Council Assessment Panel Agenda & Reports

20 October 2025

We act for NIC Design Studio (**Proponent**). The Proponent seeks planning consent (**consent**) from the City of Norwood, Payneham and St Peters (**Council**) to demolish the existing dwelling and ancillary structures at 7 Stephen Terrace, St Peters (**site**).

RE: DA 25015527 - RESPONSE TO REPRESENTATIONS

A schematic of the effect is shown below (also refer to the photographs).

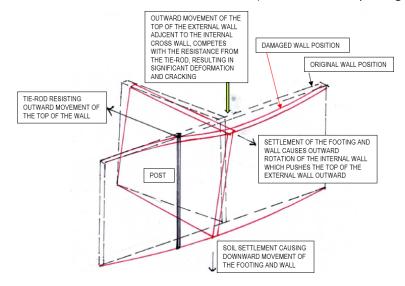
The posts and tie-rods have resisted the outward movement, but the consequential effect is that when the internal cross wall rotates outwards due to footing movement of the external wall the external wall is pushed outwards at the top but a short distance away at the steel post the top of the wall is prevented from moving outwards.

Urathane Solutions injecting in Kensington Park

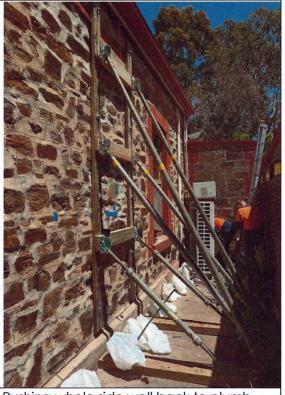
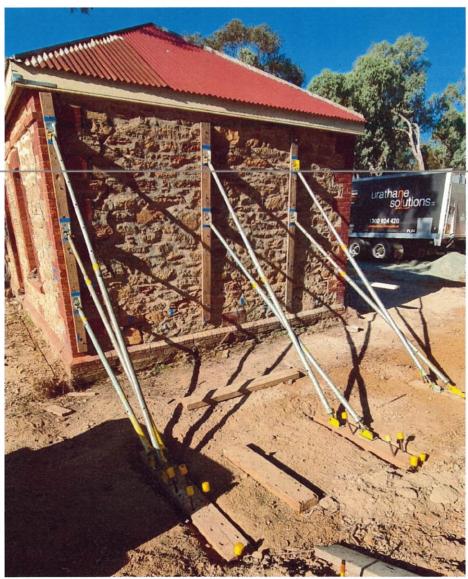
I have in recent times become aware of the capability of **Urathane Solutions** to straighten walls like this example being undertaken presently around the corner from this property at 205 Payneham Road.

Pushing whole side wall back to plumb. Cost \$20K

Mr Wilkinson advises that he has "in recent times become aware of the capability of Urathane Solutions to straighten walls" but provides not comment as to it would be suitable or unsuitable for the subject house.

Figure 2 – **Red** is damage to walls, **green** is damage to ceilings & cornices, numbers and arrows externally indicate measured rotations

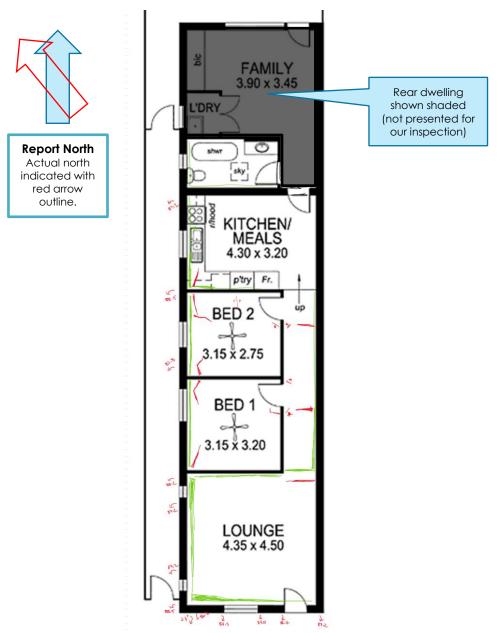
The most severe cracking, and that which we understand causes the applicant concern, was observed to the front lounge and along the western elevation (including the wall/ceiling junctions and the intersections between the western wall and internal return walls).

The southern (front) and western elevations' verticality was measured at various locations using a digital spirit level. The southern elevation was measured to be between 2.7° and 3.3° out of vertical alignment relatively consistently across its width. The western elevation was measured to be between 0.8° and 2.8° out of vertical alignment, with the severity of misalignment increasing from the rear to the front.

Figure 3 – Approximate extent of structure that may require reconstruction

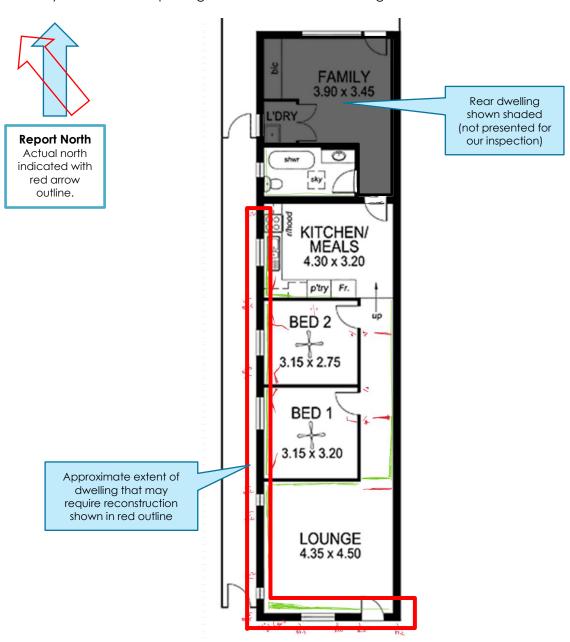
Therefore, in our opinion, for the purposes of the assessment of this application, it would be reasonable for stakeholders to allow for the affected walls to be reconstructed. The approximate extent of reconstruction works that we expect would be required is shown on Figure 3 on the following page. The reconstruction of these walls would also allow them to be underset with a damp proof course (refer also to further discussion regarding damp in the relevant sub-section of this report below).

Damp affected masonry elements would need replacing or repointing (as applicable). However, more severely affected masonry may require local rebuilding. The extent of damp affected masonry that requires the most attention is within the extent suggested be allowed for reconstruction in Figure 3 above.

- 2. It may be necessary to reconstruct the southern (front) and western elevations and local parts of the return walls to remediate the more severe movement that has occurred to these areas (refer to Figure 3 above and the associated discussion regarding realigning the existing walls).
